**STATE OF HAWAII  
DEPARTMENT OF TRANSPORTATION  
HIGHWAYS**

**ADDENDUM NO. 1  
FOR  
INTERSTATE ROUTE H-1, MCCULLY STREET SEPARATION,  
SEISMIC RETROFIT  
FEDERAL-AID PROJECT NO. NH-H1-1(284)  
DISTRICT OF HONOLULU  
ISLAND OF OAHU**

**May 1, 2026**

**BEARING RETROFIT DETAILS**

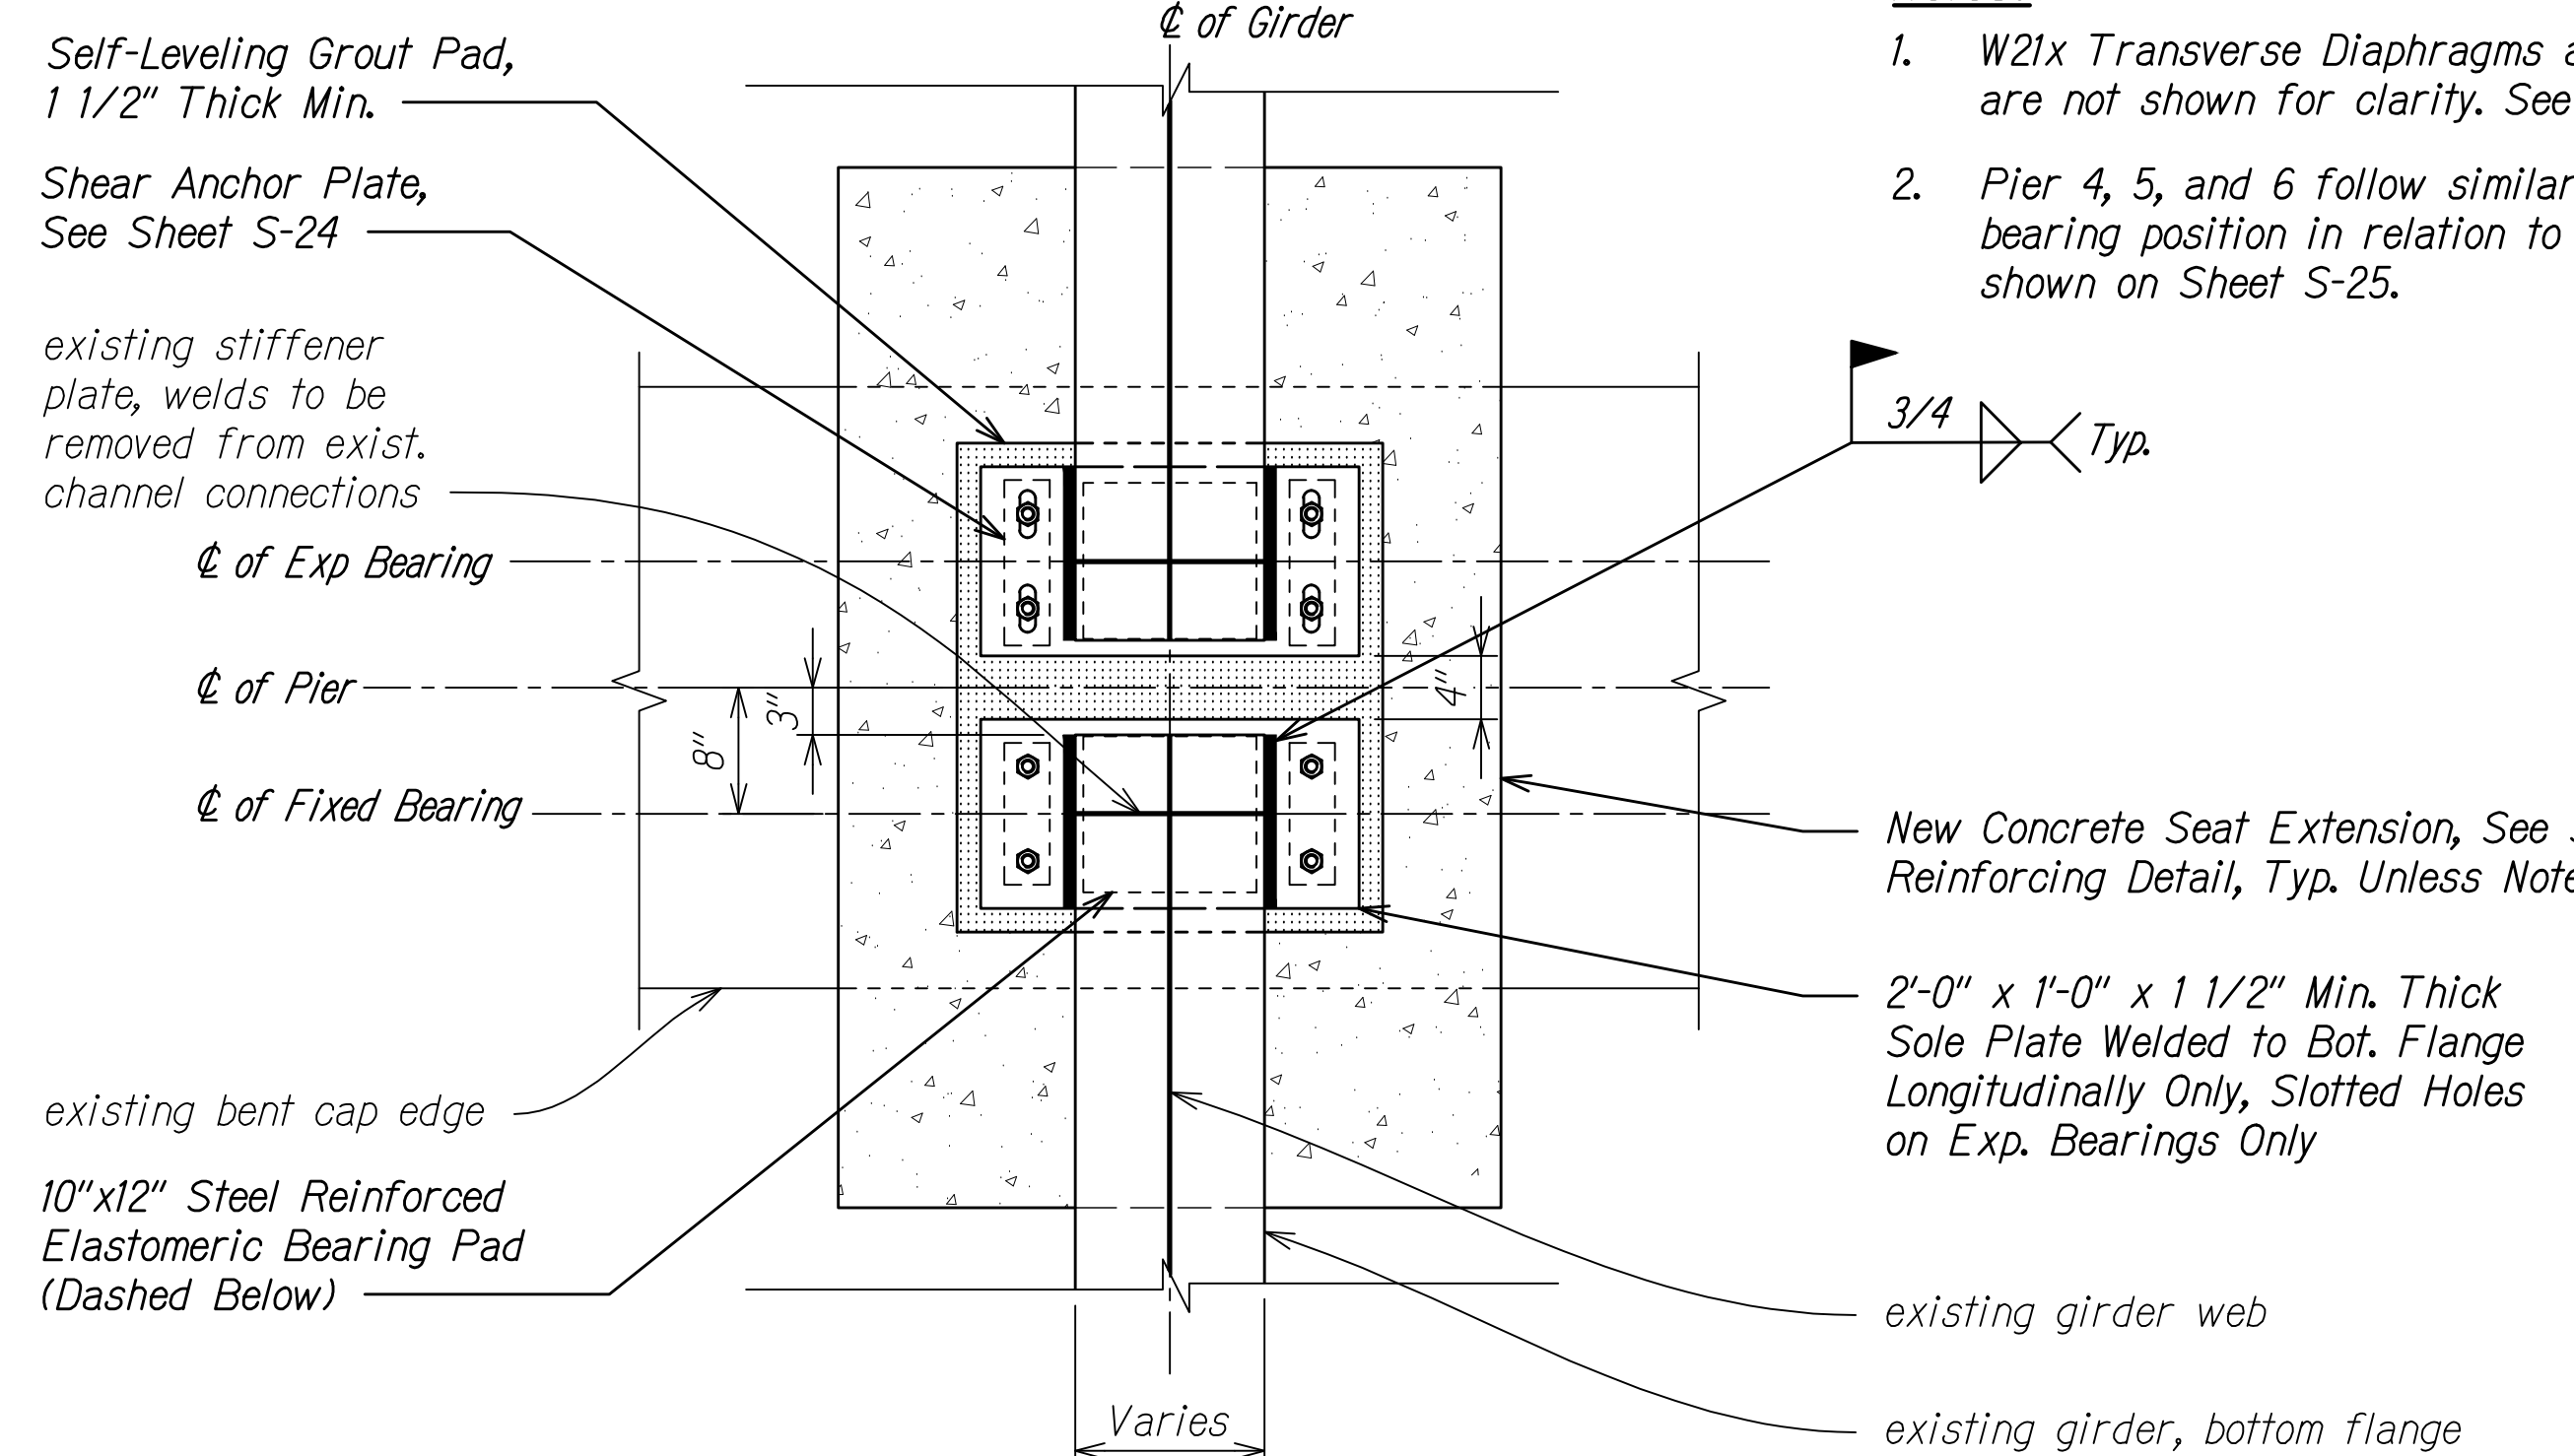
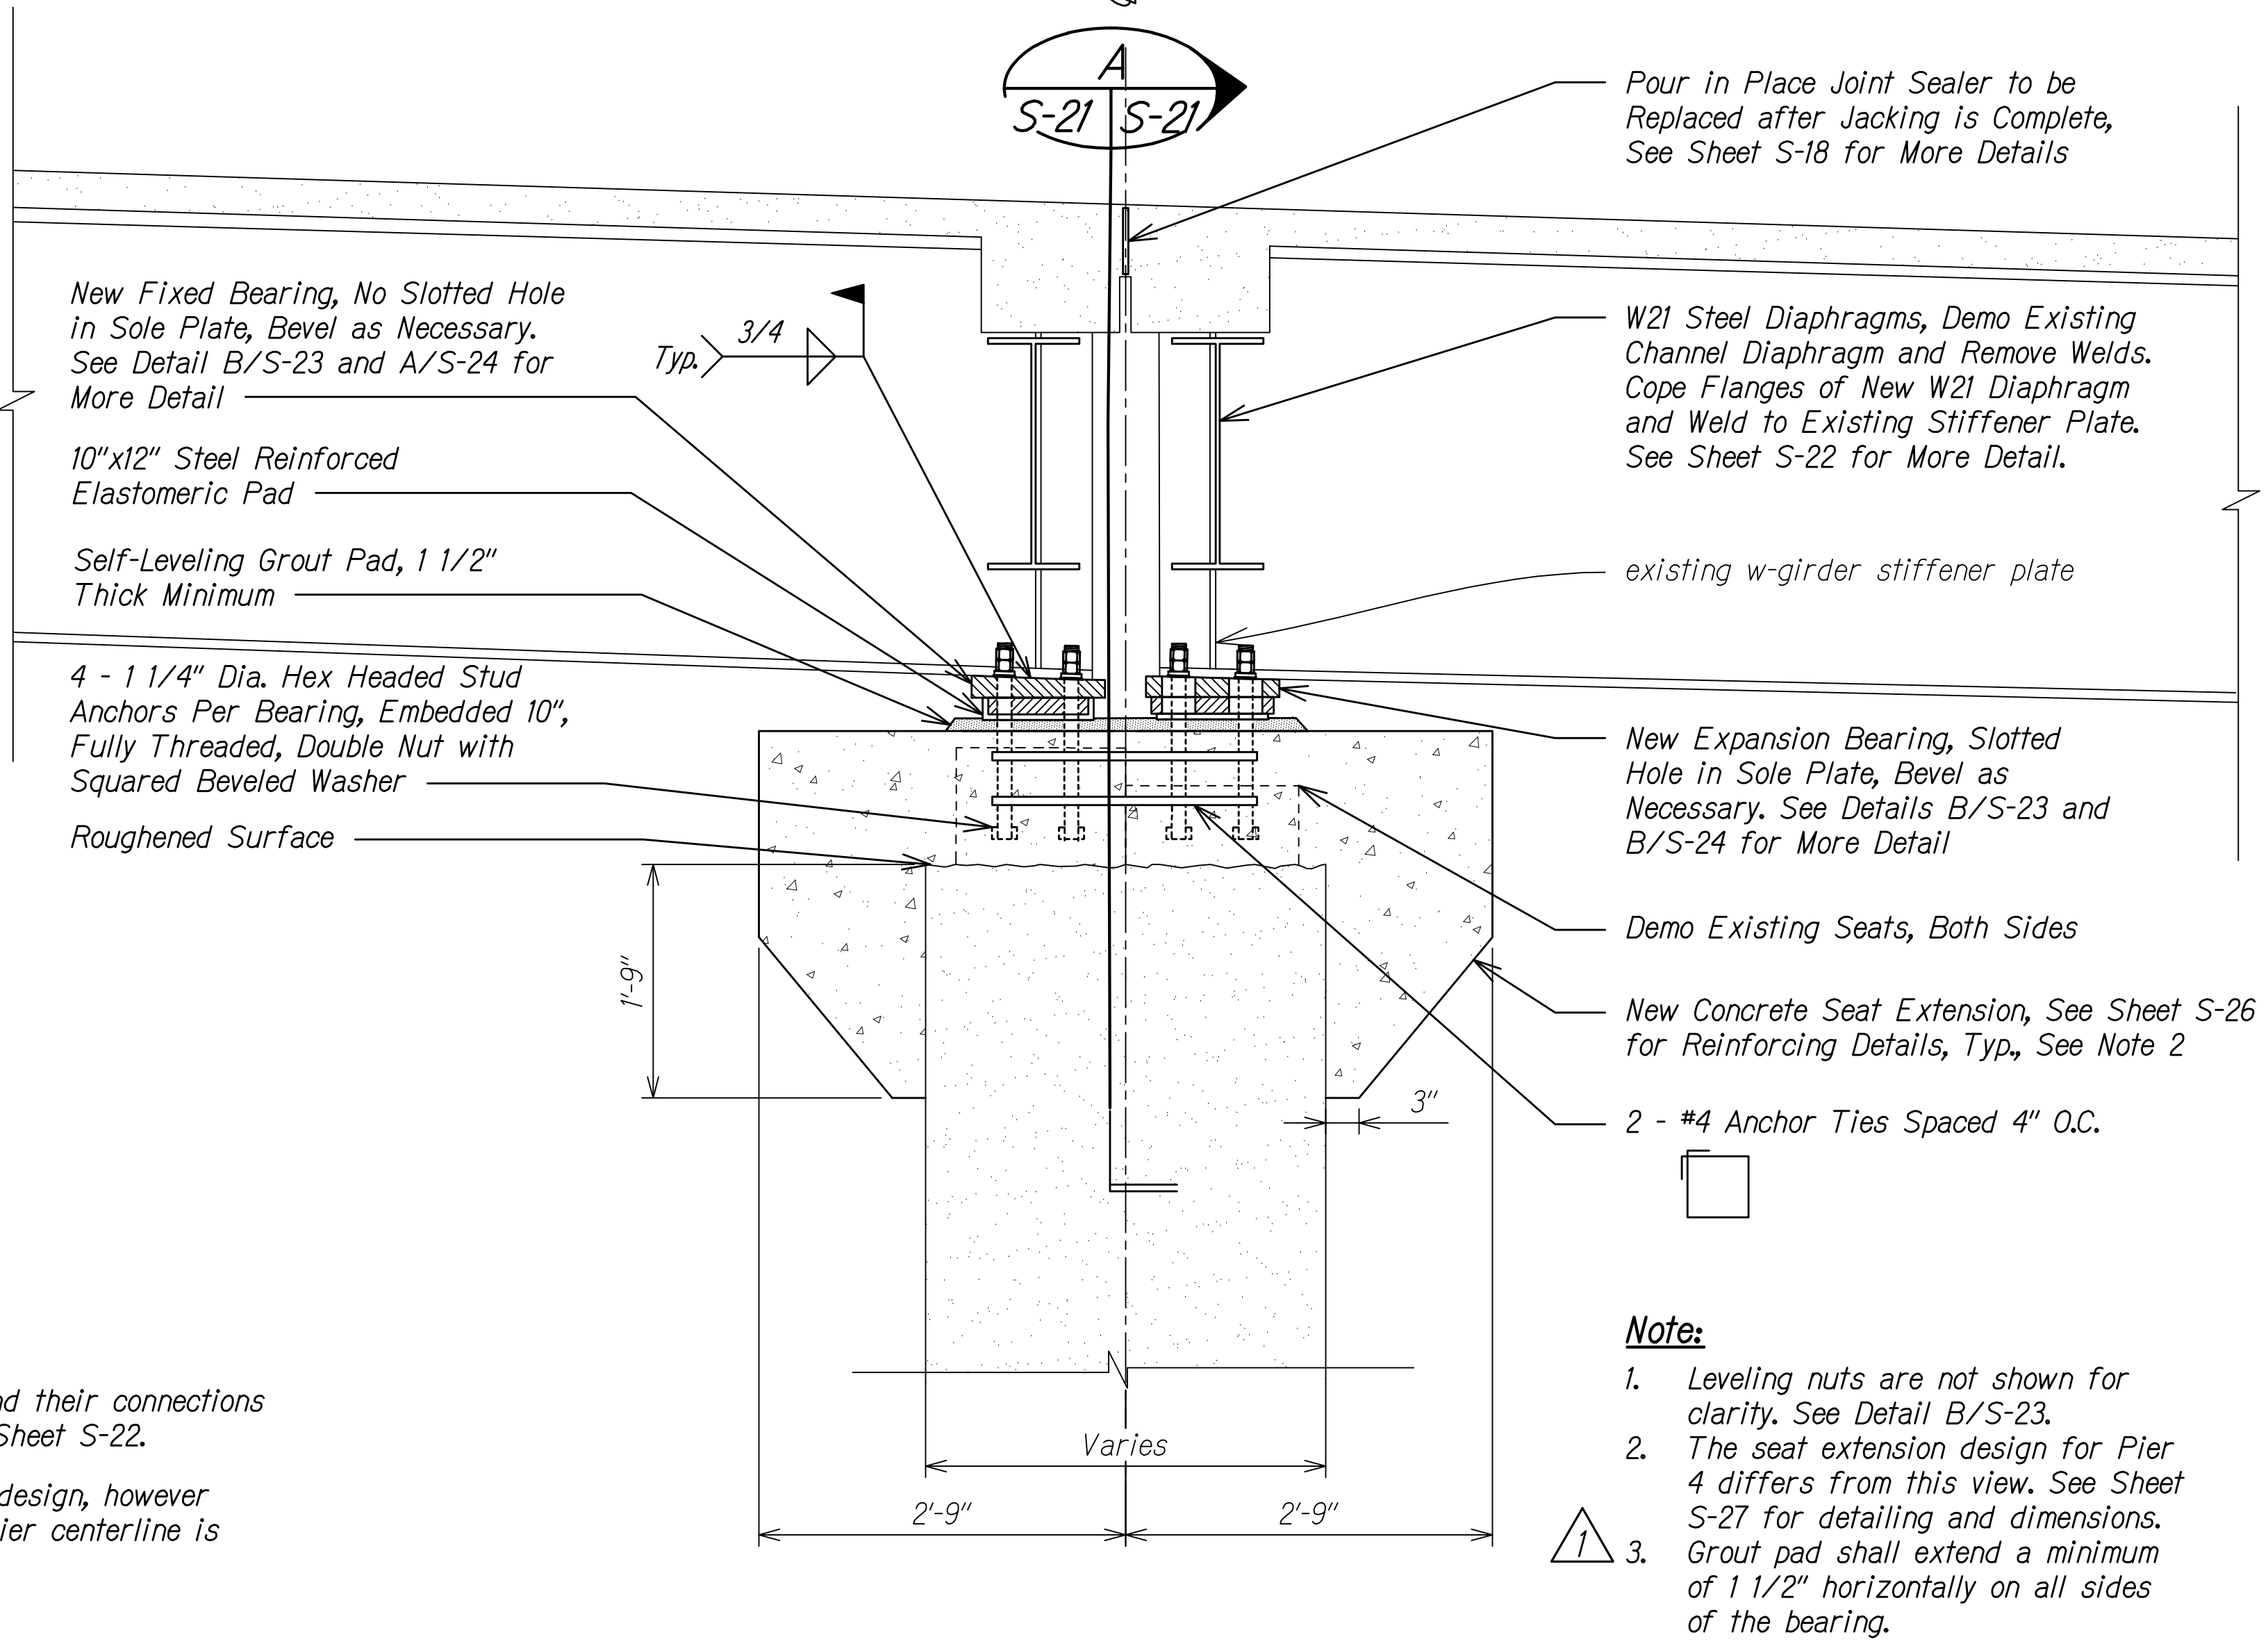
4/21/26	1	Added grout pad extension dimension.
DATE		REVISION

- Note:**
- Leveling nuts are not shown for clarity. See Detail B/S-23.
  - The seat extension design for Pier 4 differs from this view. See Sheet S-27 for detailing and dimensions.
  - Grout pad shall extend a minimum of 1 1/2" horizontally on all sides of the bearing.
